ADDENDUM NO. 3

DATE: October 12, 2017
FROM: City of Grand Junction Purchasing Division
TO: All Offerors
RE: Kannah Creek Intake Rehabilitation IFB-4414-17-DH

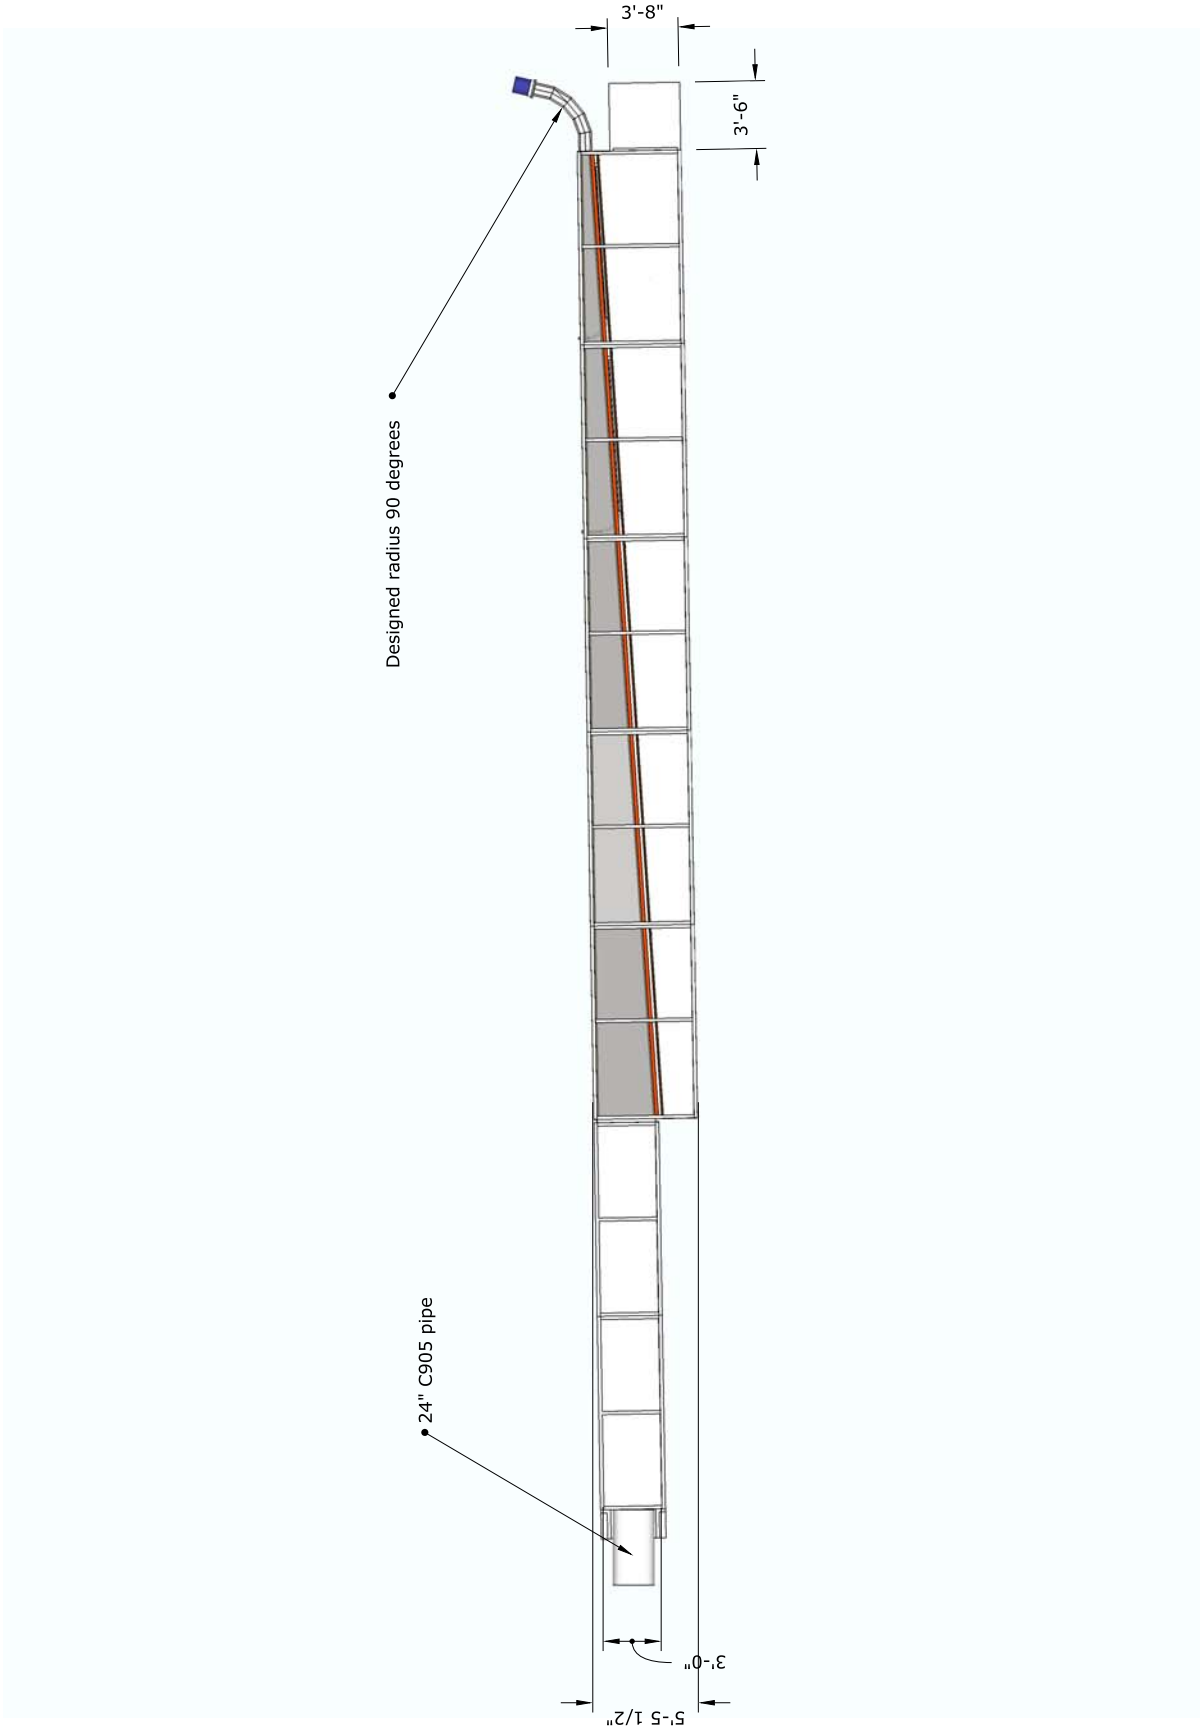
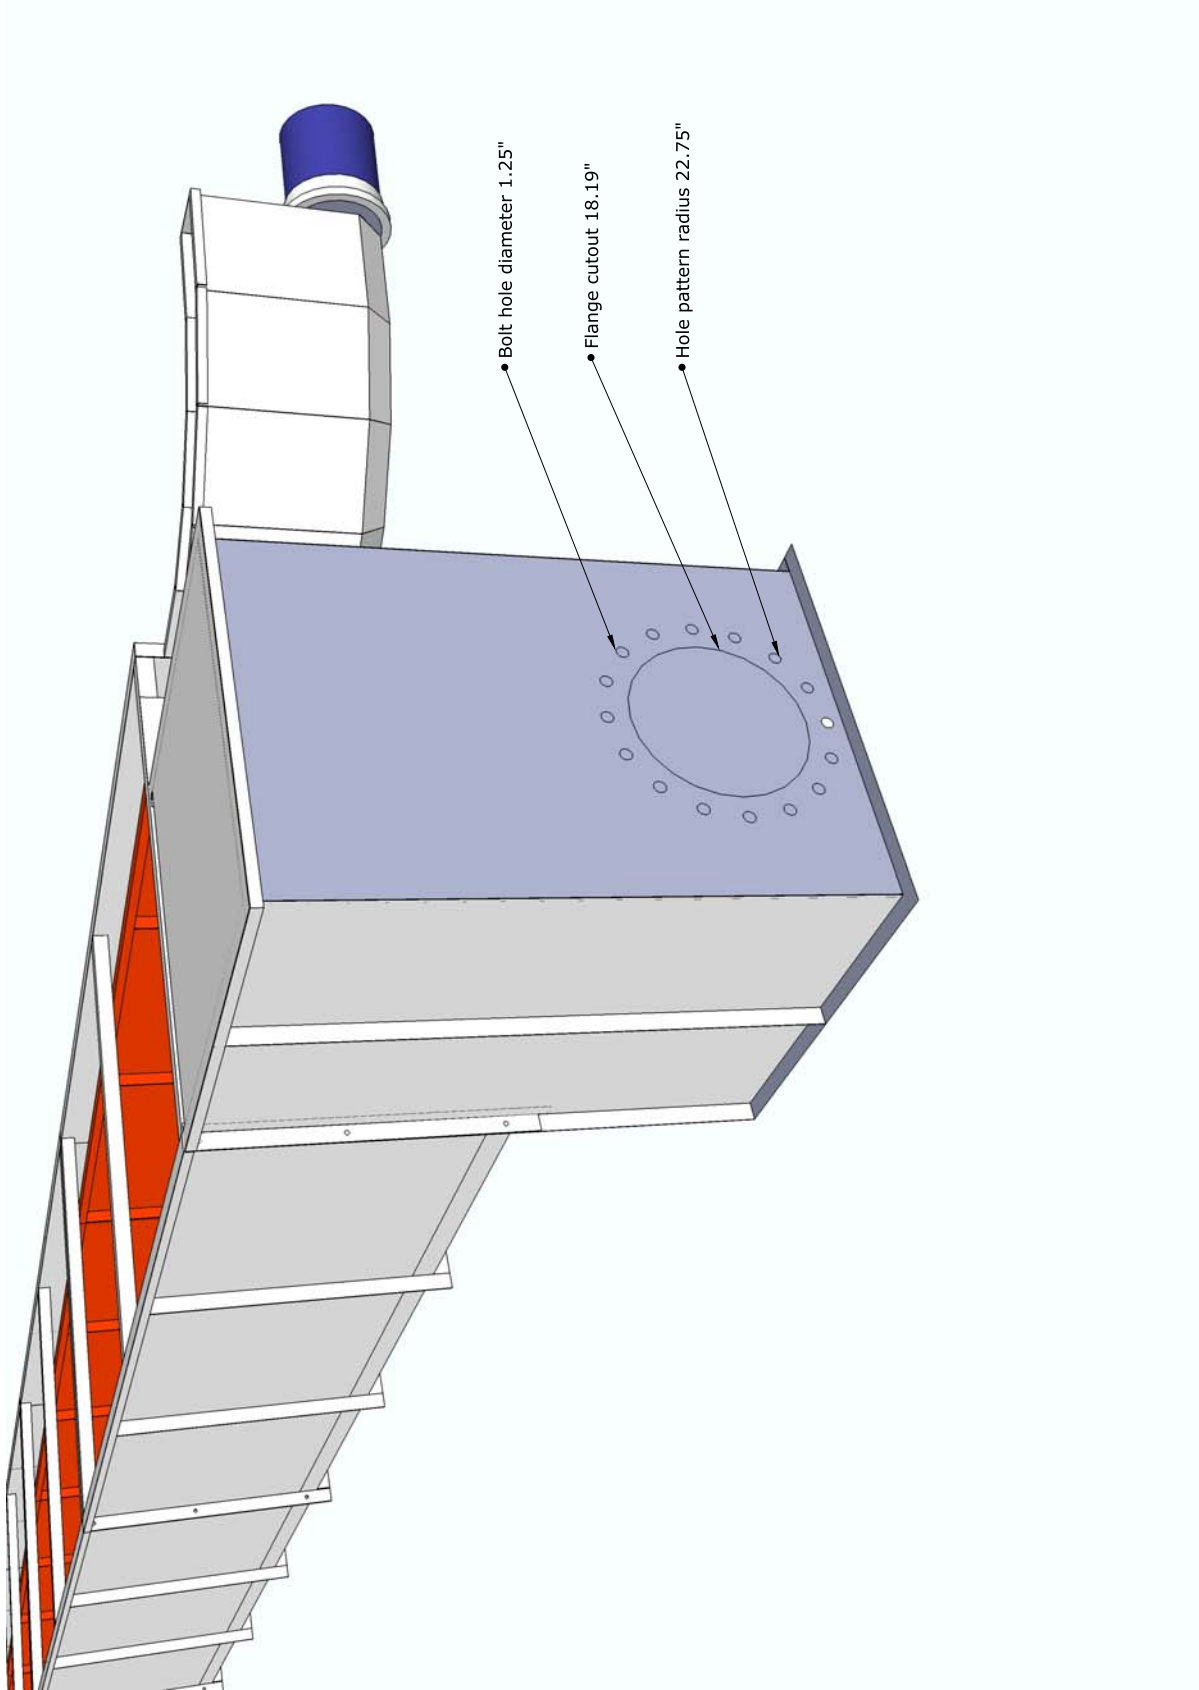
1. For the contractor's convenience, please see the attached water screen drawings.
